PARTS & SERVICE NEWS

REF NO.	AT04006
DATE	Feb. 3, 2004
(C) Page 1 of 4

SUBJECT: IMPROVED HEATER HOSE CLAMPS FOR HD465-7 AND HD605-7

PURPOSE: To introduce the improved heater hose clamps for HD465-7 and HD605-7.

Fig.1 Drawing of Removal

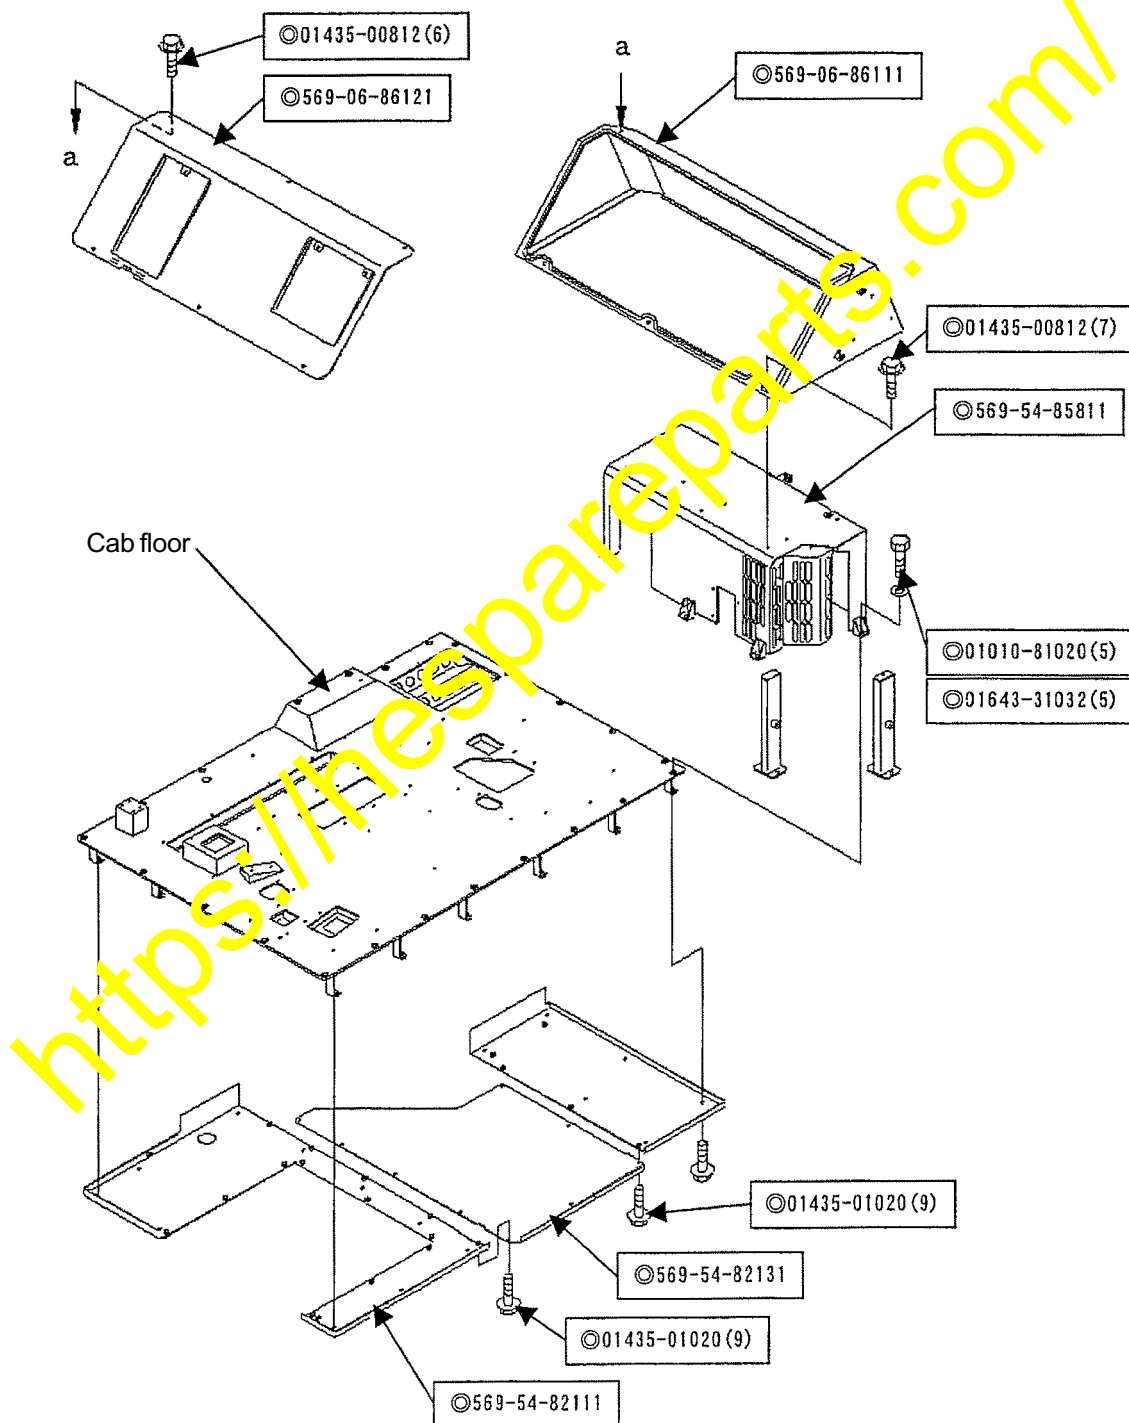
Remove the parts marked with a double circle (See Fig.1).

Store the parts with a double circle as they will be reused.

Fig. 2 Drawing of Replacement of Clamps

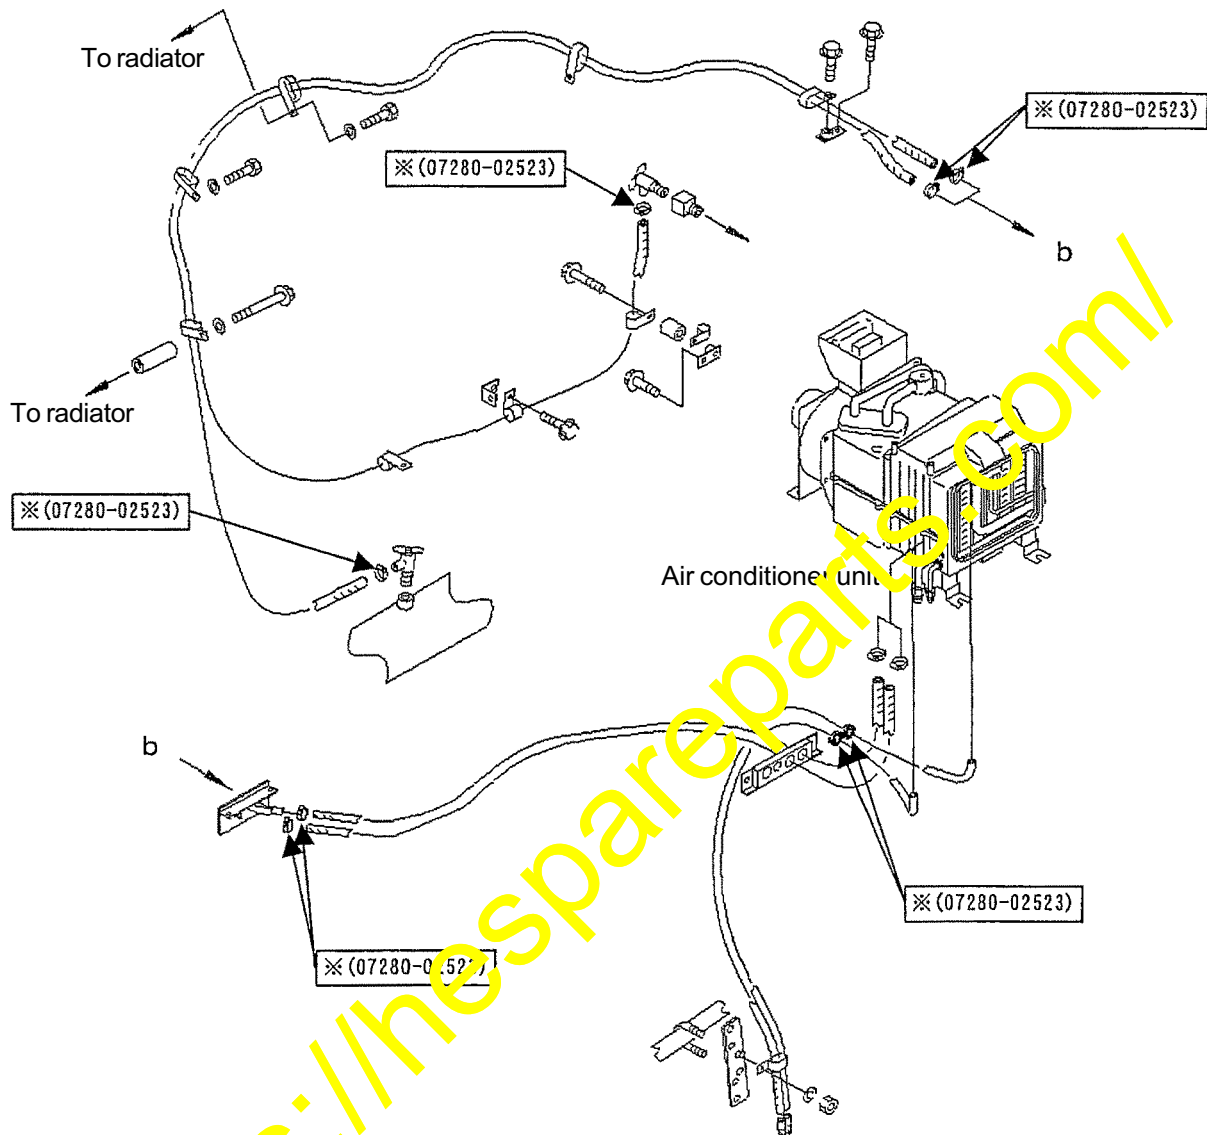
Replace the clamps marked with an asterisk with improved ones (09479-02400) (8 places).

Prior to improvement (07280-02523)	After improvement (09479-02400)
Shape		
Resisting pressure	490 kPa (5 kg/cm ²)	686.5 kPa (7 kg/cm ²)
Tightening method	Tightening to 2.9 Nm (30 kgcm)	Removing the holder (3).

The clip is to be replaced with the one that has higher resisting pressure and suitability for assembly.
